SAS-2 MiniSAS Channel Characteristics with Return Pin Removal (08-292r0)

Barry Olawsky
Hewlett Packard
(7/15/2008)

S21 for Transmit Pairs 3 and 4

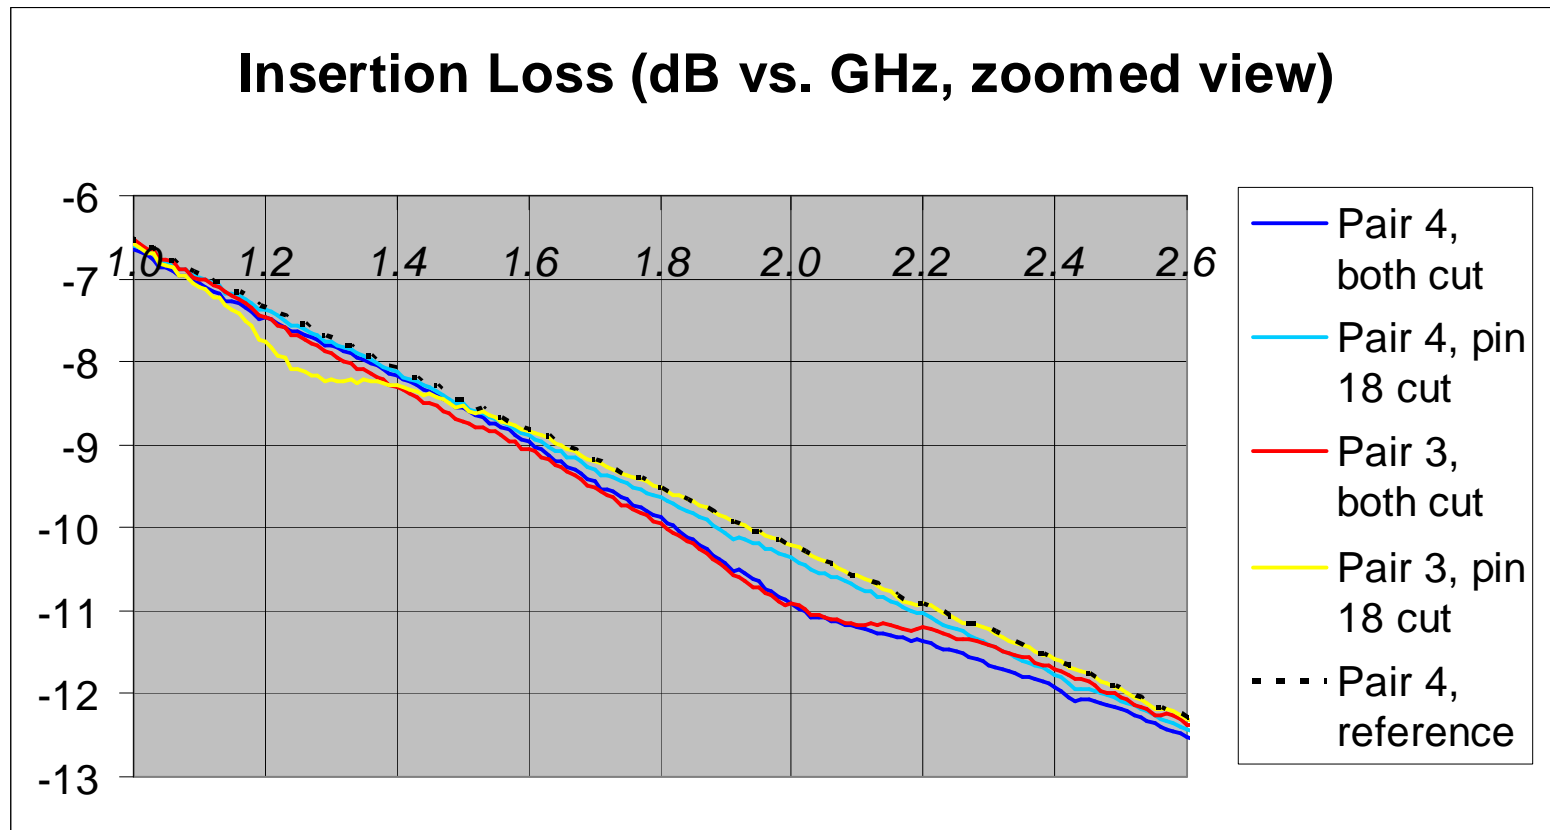
- Channel deterioration appears to be worse with both B15 and B18 severed.
- Under 6GHz, the additional channel attenuation peaked at less than 1dB
- Pairs three and four appeared to deteriorate a similar amount even though pair four is isolated when both B15 and B18 are removed
- Other effects of test boards have not been de-embedded from the measurement

S11 for Transmit Pairs 3 and 4

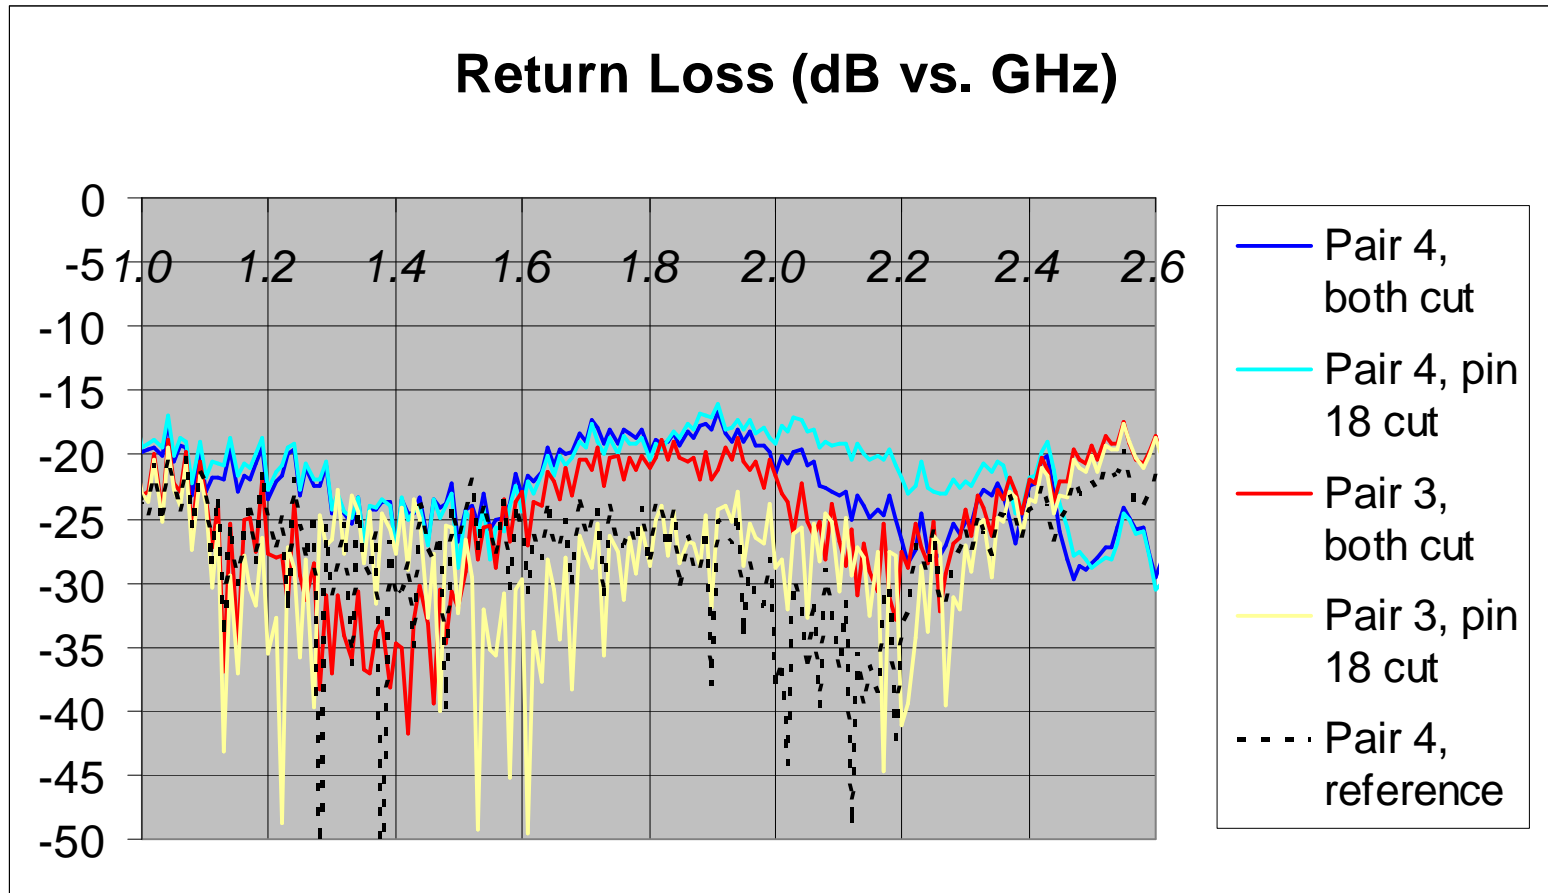
- Channel deterioration appears to be negligible for pair three when B18 is severed. Dominant signal return paths for pair 3 are B15 and B12
- Under 6GHz, the return loss is as much as ~7dB higher
- Other effects of test boards have not been de-embedded from the measurement

Crosstalk for TX4 Aggressor Pair

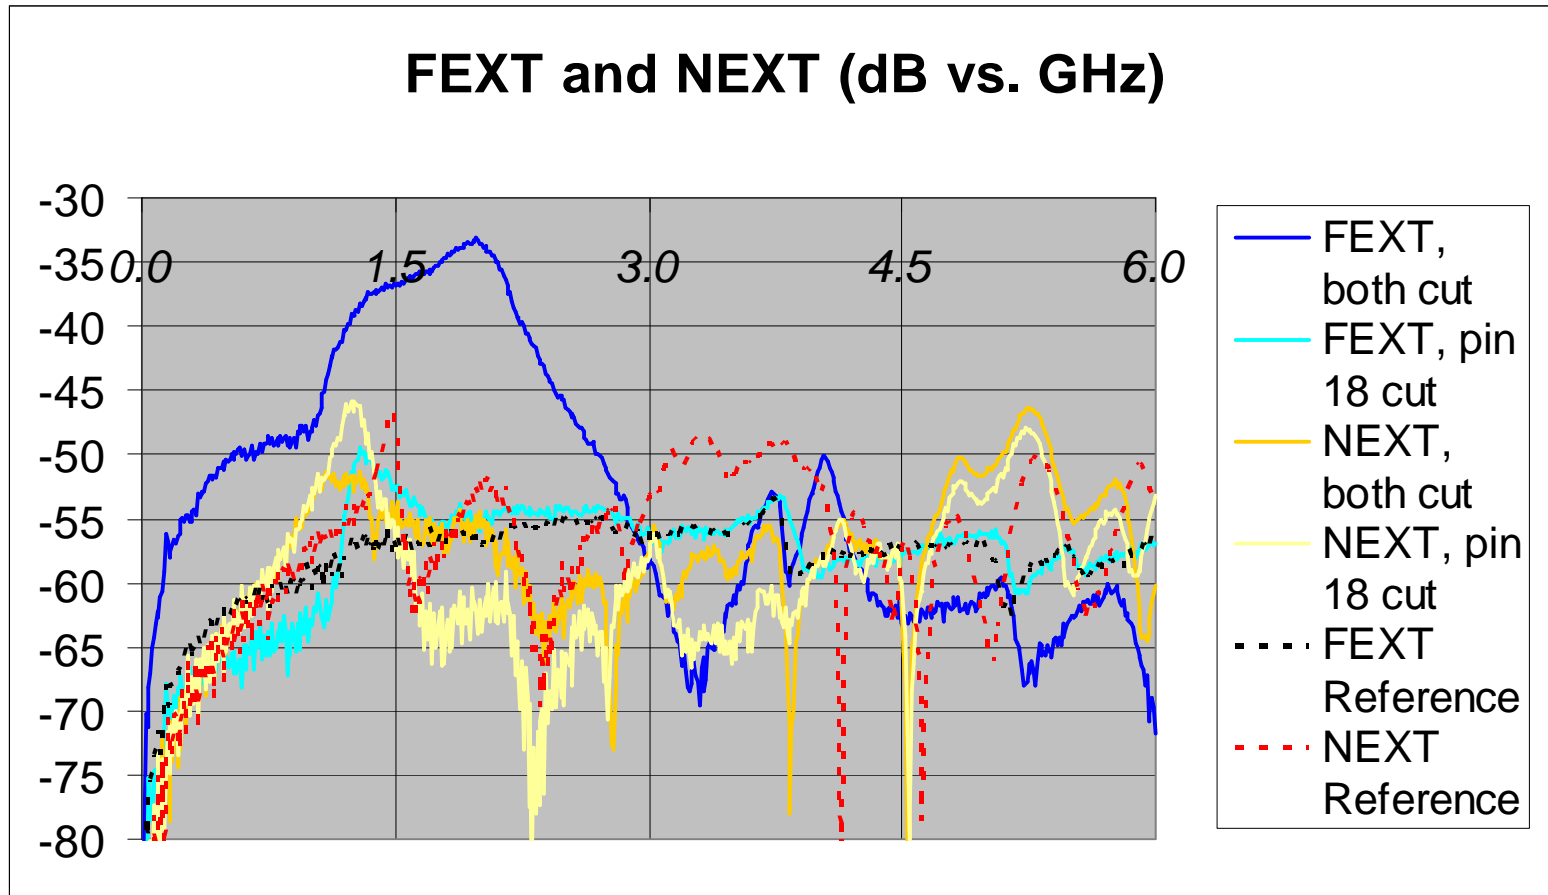
- NEXT characteristics change with respect to frequency but it is not conclusive that severing of B15 and B18 increase the levels
- The negative effects of severing B15 and B18 are evident in the FEXT results. B15 isolates TX pairs three and four. It's unclear from the data if severing only B15 would result in FEXT levels seen when both B15 and B18 are severed.
